SUBJECT: NuScale Power, LLC Response to NRC Request for Additional Information No. 244 (eRAI No. 9013) on the NuScale Design Certification Application

eRAI No.: 9013

NRC Question No.: 09.01.02-32

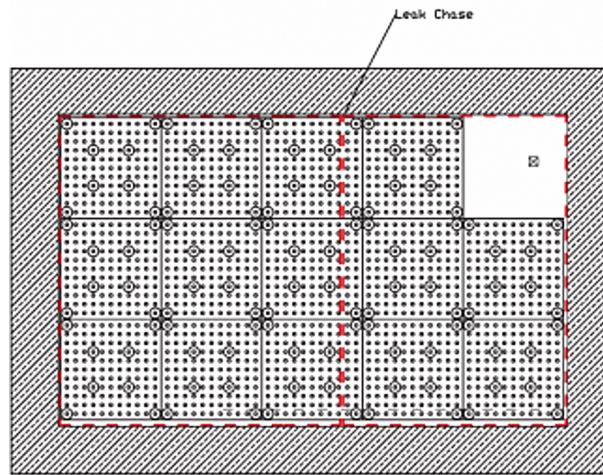
The applicant should explain the design evaluations for the loads imparted on the pool liner and concrete floor immediately below the rack legs. The applicant should address if the rack leg bearing plates were properly sized to avoid crushing the concrete in the localized region. The applicant should also explain whether the rack legs, including the bearing plates, are designed to avoid damaging the leak chase channels, and describe whether the rack legs and leak chase channels are located in positions to avoid the rack leg impact forces on the leak chase channels. The applicant should describe whether rack movement due to seismic displacement of the racks is also considered in this evaluation.

Evaluations were performed to determine stresses in the liner plate and concrete underlying the spent fuel rack legs under maximum leg loading. The demand-capacity ratio of the liner stress under these conditions is 0.08. The design-capacity ratio of concrete punching shear is 0.07. The design-capacity ratio of concrete bearing is 0.44. Since these are all less than 1.0, they are acceptable and demonstrate sufficient margin for the liner and concrete beneath the spent fuel rack and indicate that the rack bearing plates are properly sized.

The leak chase system was laid out in such a way as to avoid being beneath the fuel rack legs, when the racks are initially placed, as depicted in the general arrangement sketch below. Because of the closely spaced arrangement of the racks, it cannot be guaranteed that a rack leg will not end up directly on top of a leak chase channel after seismic displacement of the racks. However, due to the bearing plate design, the liner stress is so low, even for maximum loading conditions, the leak chase system bears no risk of being damaged.
